Council File Reference: MCU19/0114 & RAL19/0027

RE: RESPONSE TO INFORMATION REQUEST
Development Application MCU19/0114 & RAL19/0027
30, 114, 122 and 144 Myall St Cooroy Qld 4563
(Lot 33 MCH 2281 and Lots 1, 2 and 3 on SP 115864)

3. Response to each item raised in information request dated 18 October 2019

Figure 1 – Map extract showing 400m walkable radius from site entry

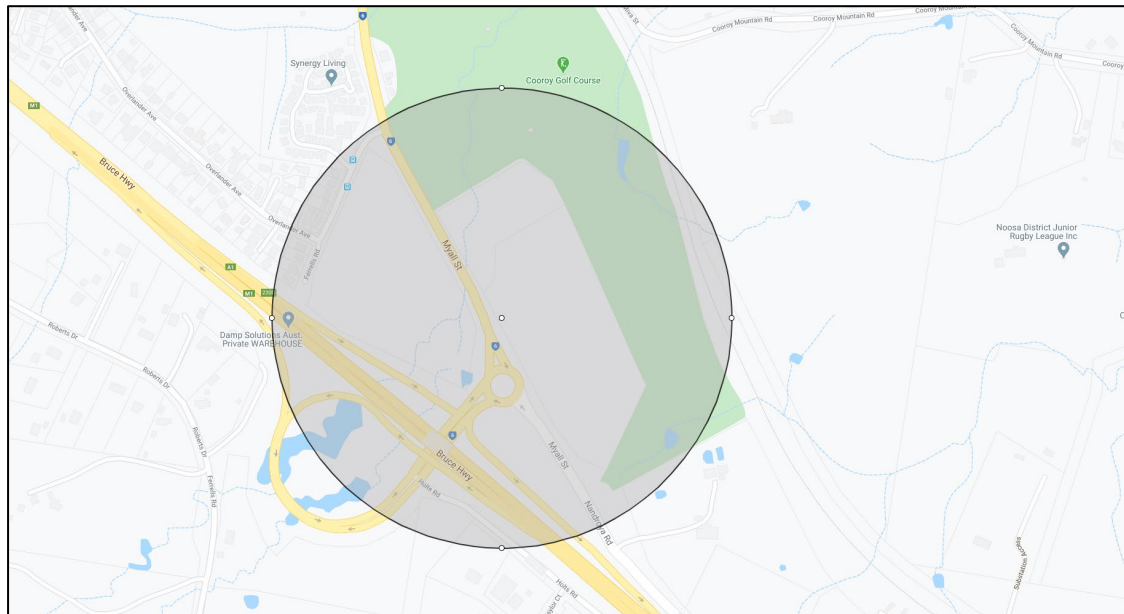
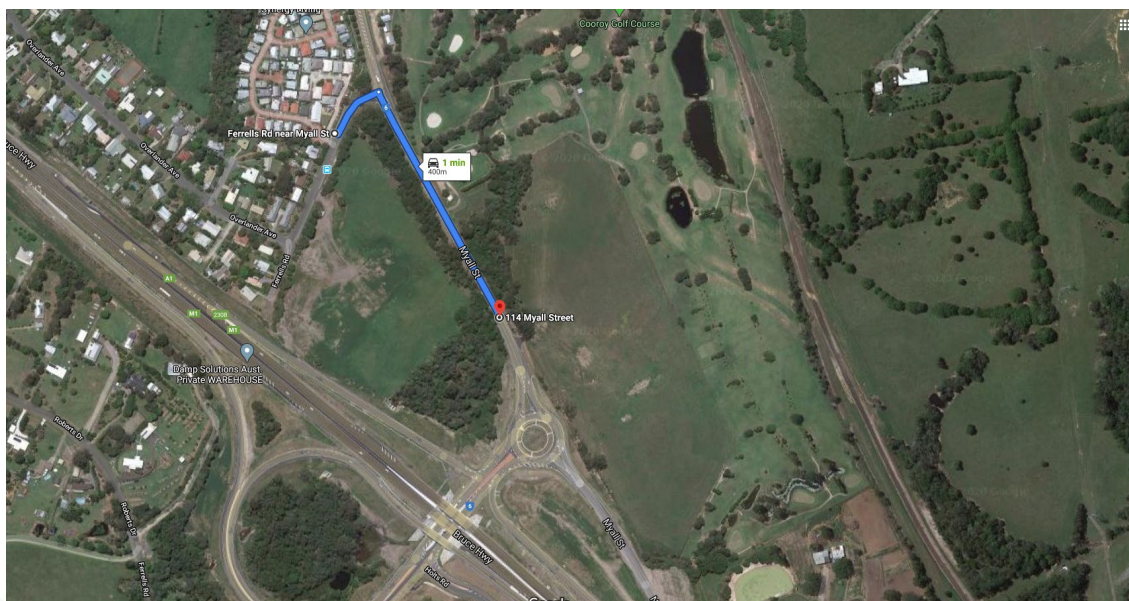
Item 12 – Demonstrate how satisfactory walking distances (400m) to public transport services for residents of the development will be achieved. If this involves a proposal for altered public transport routes and new bus stops, then details are to be provided, including agreement from Translink.

Response – Figures 1 and 2 below show that there are 2 public bus stops available within 400m from the site entry along Ferrells Road. In addition to the option of public transport, GemLife also provide a minibus on site which is available to take residents on shopping trips and other outings as required.

Figure 6: Proposed Signage and Location

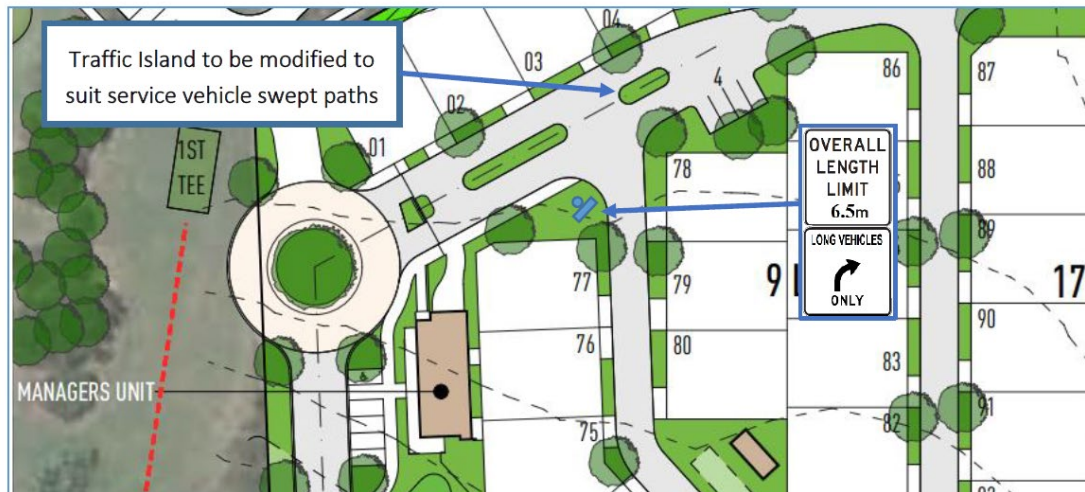
Item 19 – Provide details of signage to prohibit truck movements in the northbound direction along the roadway past lots 74-76, and to also increase the kerb return radii at the proposed roundabout to improve its operation and to also enable painted splitter islands to be introduced as a minimum.

“TTM have investigated altering the proposed development to accommodate the truck movements in the northbound direction past lots 74-76. To accommodate the large turning circle required for the nominated design vehicle clear of the secured entry gate, the island separating the northbound roadway and the entry roadway into the site would need to be significantly truncated. The provision of this truncation would provide an unacceptable alignment, opening up and negatively impacting the operation and safety of the proposed intersection. Further to this, a security gate is provided at the entrance to the site. TTM have been informed that the span created by the incorporation of this truncation could not be secured by the proposed security arrangements. It is worth noting that TTM’s original traffic report proposed to restrict service vehicle movements to one-way along this circulation road, with refuse collection achieved via a bin pad positioned adjacent to the Bocce Court. As the revised development scheme has increased the number of units along the northern side of this circulation road to 8, the bin pad would need to facilitate 16 bins (2

bins per dwelling). Taking into consideration the area that would be required to accommodate these demands, it was considered a superior outcome to restrict northbound service vehicle movements to right-turns only. All southbound service vehicle movements are unrestricted. To enforce these arrangements, it is proposed that signage dictating the vehicle length and movements restrictions be installed at the intersection, as illustrated in Figure 6. The proposed signage will be a combination of Manual of Uniform Traffic Control Devices (MUTCD) sign R6-33 and a customised R2-14A sign.

“On this basis of the above, the restriction of left-turn movements for northbound service vehicles is considered to be acceptable and will not significantly impact the general accessibility of the adjacent dwellings.”
